UNITED STATES PATENT AND TRADEMARK OFFICE

APPLICATION NO.	FILING DATE	FIRST NAMED INVENTOR	ATTORNEY DOCKET NO.	CONFIRMATION NO.
09/901,079	07/10/2001	Dong-Hoon Lee	8733.464.00	7082

Office Action Summary

DETAILED ACTION

APA, Figure 6:

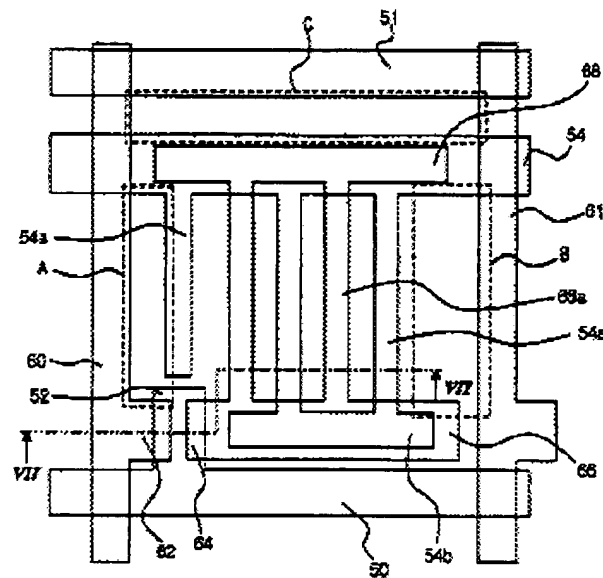
As to claim 1, APA discloses an in-plane switching liquid crystal display device comprising:

first and second substrates, 30 and 32 respectively;

a gate line, 50, arranged in one direction on the first substrate;

a common line, 54, arranged on the first substrate;

a gate insulation layer, 70, on the first substrate;

a data line, 62, on the gate insulation layer;

a first passivation layer, 74, on the gate insulation layer, and a plurality of common electrodes, 54a, an insulating layer over the common electrodes, and a plurality of pixel electrodes, 66a, on said insulating layer, wherein the plurality of common electrodes and the plurality of pixel electrodes are parallel to and [Applicant's "an"] space apart from each other; and

As to claim 31, APA discloses, in Figure 6, pixel electrodes electrically communicated with one another via a transverse pixel electrode perpendicular to the common electrodes.

APA, Figure 7D:

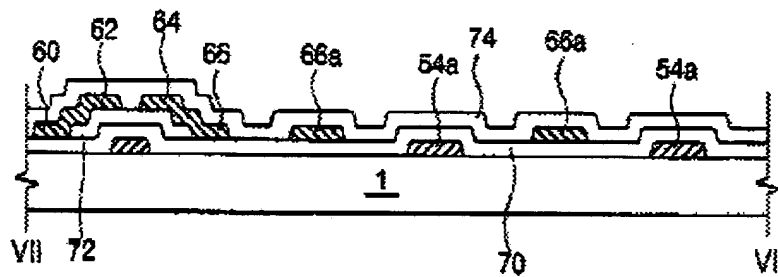
APA does not explicitly disclose a common electrode

1) in contact with the first passivation layer; a second passivation layer on the first passivation layer; a pixel electrode on the second passivation layer, wherein the first passivation layer includes a plurality of common line contact holes and wherein

each common electrode is electrically connected with the common line through the corresponding common line contact hole, and

2) wherein the second passivation layer is an inorganic material.

FIG. 3(a)

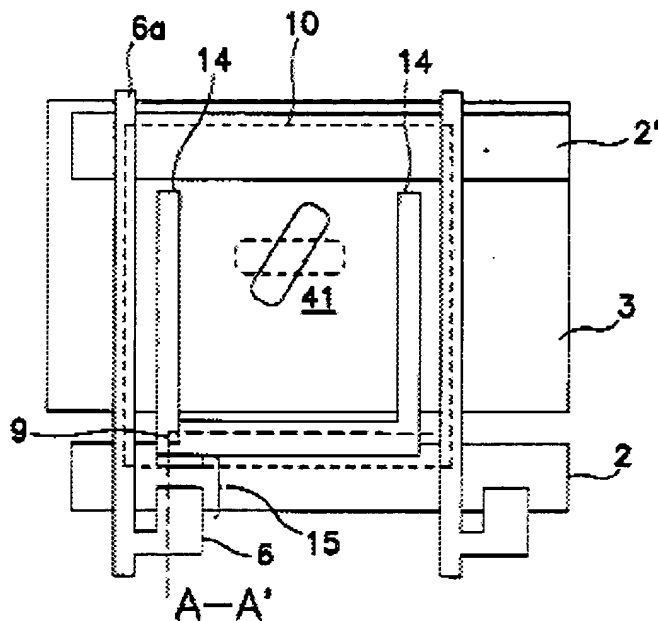
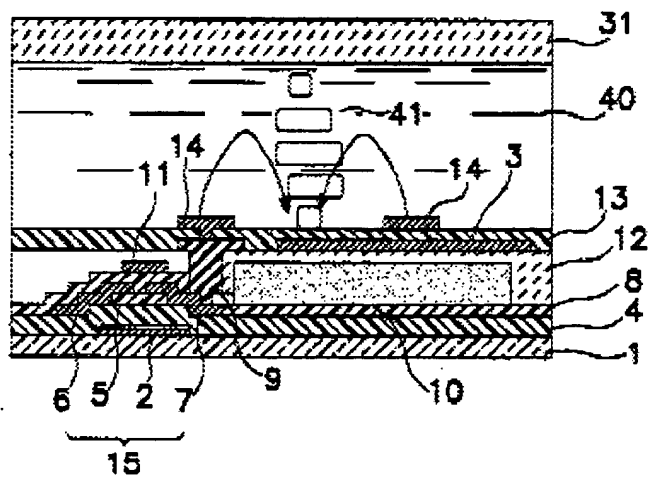
Sakamoto teaches 1), (entire patent, especially embodiment 2) in Drawings 3(a) and 3(b), the use of a common electrode, 3 (col. 8, line 23 through col. 10, line 7), on a protective overcoat layer, 12 (Applicant's the first passivation layer); an interlayer film, 13 (Applicant's second passivation layer) on the first passivation layer that includes a contact hole for connecting the pixel electrode (per Figure 3(b)); and a pixel electrode, 14, on the second passivation layer to allow for manufacture of a color display that prevents color unevenness for better display performance (col. 4, lines 1-2).

Sakamoto is evidence that ordinary workers in the art of liquid crystals would find the reason, suggestion, or motivation to move the plurality of common electrodes of APA to be on and in contact with the first passivation layer with contact holes in the first passivation layer as needed to connect a plurality of common electrodes to the common line of APA; a second passivation layer on the first passivation layer; and a pixel electrode on the second passivation layer to allow for easy manufacture of a color display that prevents color unevenness for better display performance.

As to claims 13 and 14, Sakamoto discloses a device wherein the second passivation layer includes a drain contact hole to electrically connect the pixel electrode to the drain (per Figure 3(B)).
